ADDENDUM NO. 1
TO
CITY OF AUBURN, MAINE
116-118 Hampshire St. Lead Abatement Bid #2025-005
DATE: 9/3/24

Lead Design Specifications

Bid #:	2025-005 116-118 Hampshire Street Lead Abatement
Date:	9/3/2024

Interior Property Drawing – Second Floor
116-118 Hampshire Street, Apt. 4, Auburn, ME

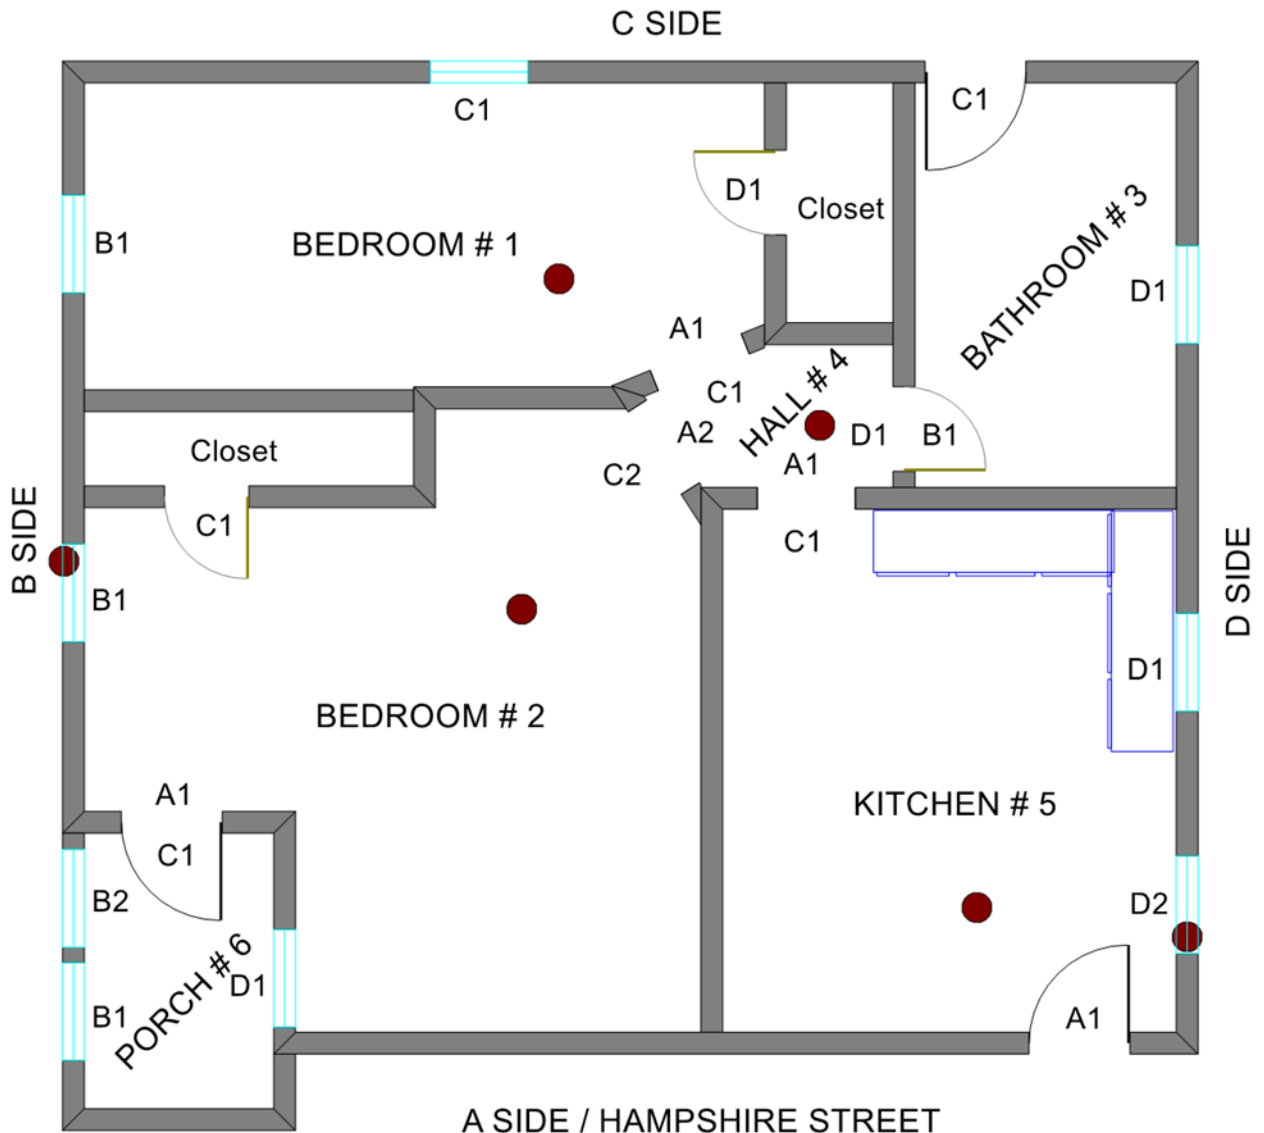
Apartment #4 Porch (aka Porch #6)

- Excessive collection of items on the porch previously prevented the lead inspector adequate access to all components in this area. Re-inspection occurred on 9/2/24 and the following components were added to the lead design:

- This porch has the same dimension as Apartment #6’s porch.

Porch #6	Walls	All	Enclosure
	Ceiling & Crown Molding	Entire	Remove & Replace
	Floor	Entire	Enclosure
	Header	B	SPP – Encapsulate
	Window Sill & Case	B1, B2	SPP – Encapsulate: Case STB – Paint: Sill

**Exterior Property Drawing –
116-118 Hampshire Street, Auburn, ME**

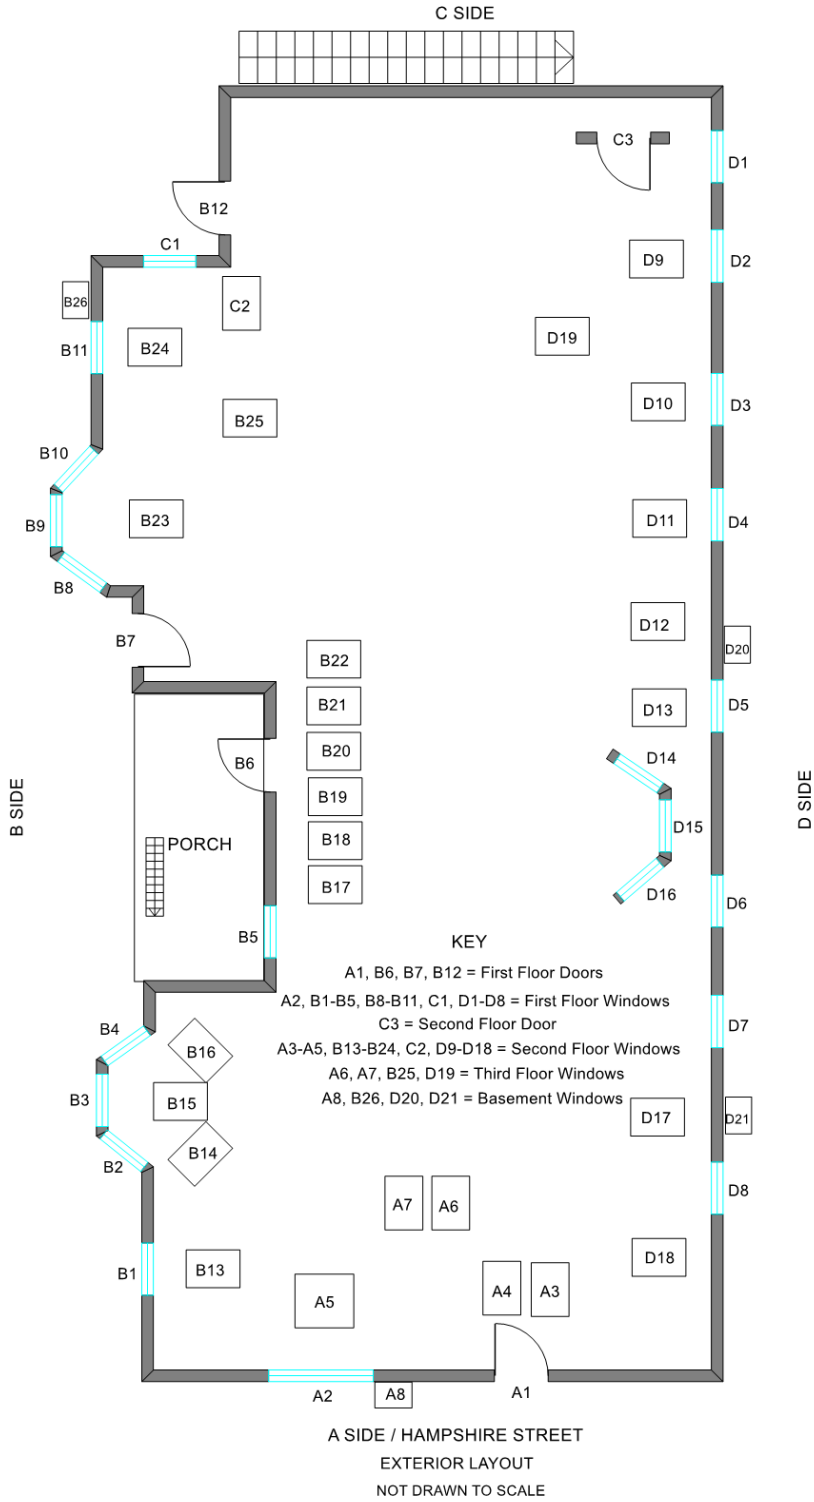
Exterior Window Sashes A6 & A7

- The owner would like to replace both of these windows with a single large window instead of two arched, decorative windows.

Exterior Side B Porch

- Condition of the porch roof is questionable and will not be known until construction begins. Inspector added "fix structure of roof and trim on B side Porch area as needed" to the design.

Interior Property Drawing – First Floor

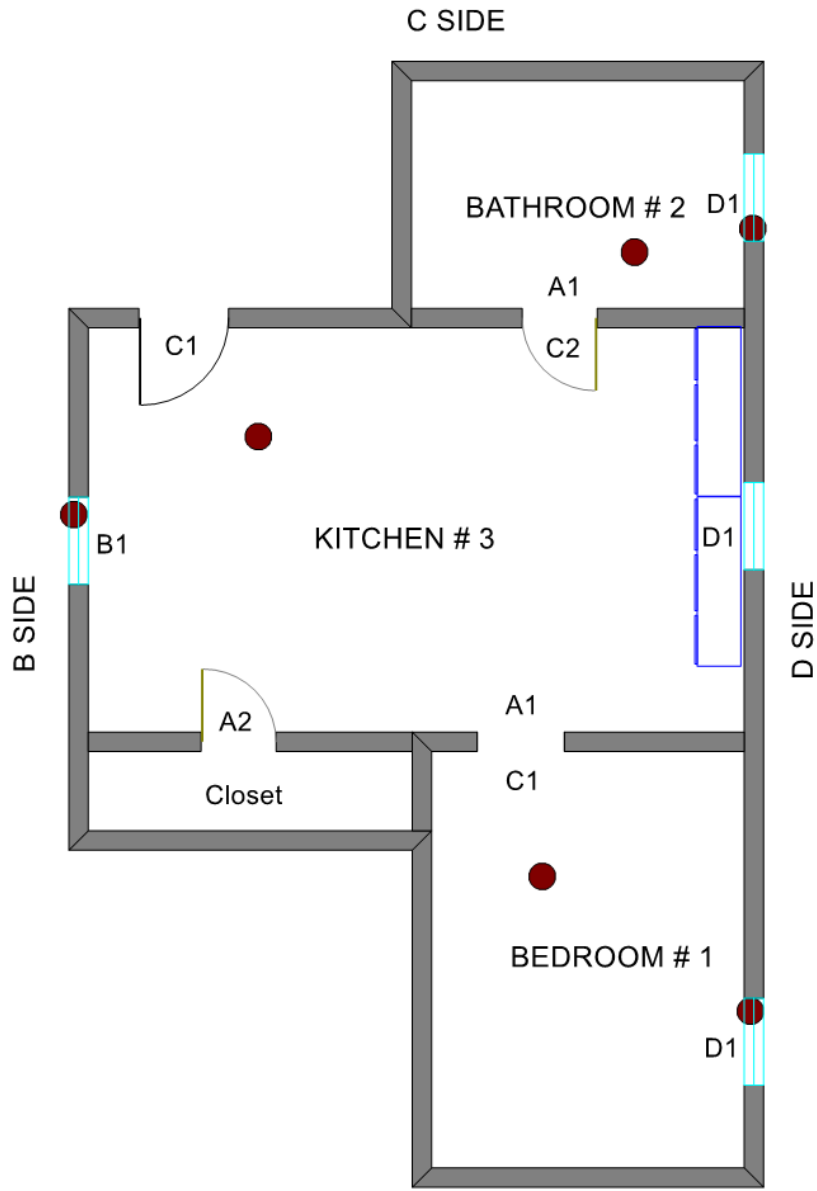
Apartment 2 Kitchen Cabinets

- Abatement method revised from Remove and Replace to the following:

Cabinets	All	STB – Paint: F/I surfaces on Doors & Drawers SPP – Encapsulate: Remainder of All Cabinet Surfaces Enclosure: Shelves
-----------------	------------	--
